DEPARTMENT OF
ENVIRONMENTAL HEALTH
MECKLENBURG COUNTY,
NORTH CAROLINA

SITE EVALUATION

S.I.R. NO. 20816

OWNER: Mary Kiser Clinton
ADDRESS: C-21 American, 6135 Park Road suite 101
Charlotte, N.C. 28210
LOCATION OF SITE: 9109 Sardis Road

**See Diagram on Back (includes: soil areas, property lines, roads, streams, gullies, wet areas, fill areas, wells, water bodies, slopes)

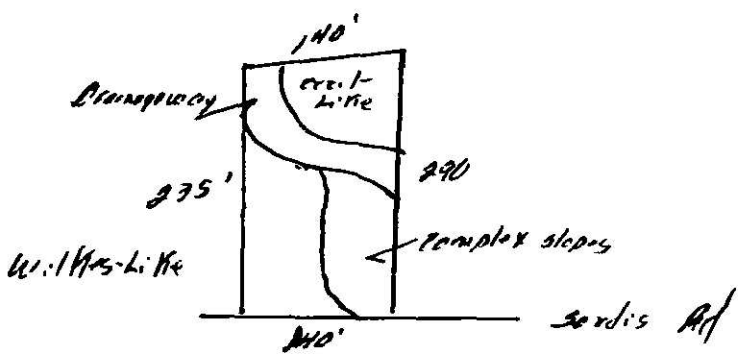
FACTORS	AREA 1	AREA 2	AREA 3	AREA 4
1. SLOPE (%)	S / PS 10-20% / U	S / PS 2-10% / U	S / PS complex slopes / U	S / PS 2-10% / U
2. SOIL TEXTURE (12-36 inches) Sandy, Loamy, Clayey (Note 2-1 Clay)	S / PS sandy loam / U	S / PS — / U	S / PS — / U	S / PS clay / U

3. SOIL STRUCTURE (12-36 inches)	S Massive / PS / U	S / PS — / U	S / PS — / U	S / PS Blocky / U
4. SOIL DEPTH (inches)	S / PS 12-18" / U	S / PS — / U	S / PS — / U	S / PS 36-40 / U

5. RESTRICTIVE HORIZONS (Inches) (Impervious strata, Rock)	S saprolite / PS 12" / U	S / PS — / U	S / PS — / U	S / PS >36" / U
6. SOIL DRAINAGE/GROUNDWATER (external and internal)	S / PS >36" to ground water / U	S / PS Drainage way / U	S / PS Eroded Areas channel runoff / U	S / PS >36" to ground water / U

7. OTHER (Specify)	S / PS / U	S / PS / U	S / PS / U	S / PS Restricted Area / U
8. SOIL GROUP	IIIA	–	–	IVA
9. SITE CLASSIFICATION	unsuitable	Unsuitable	unsuitable	unsuitable

10. SOIL SERIES	Wilkes Like	Drainageway	complex slopes	Cecil Like
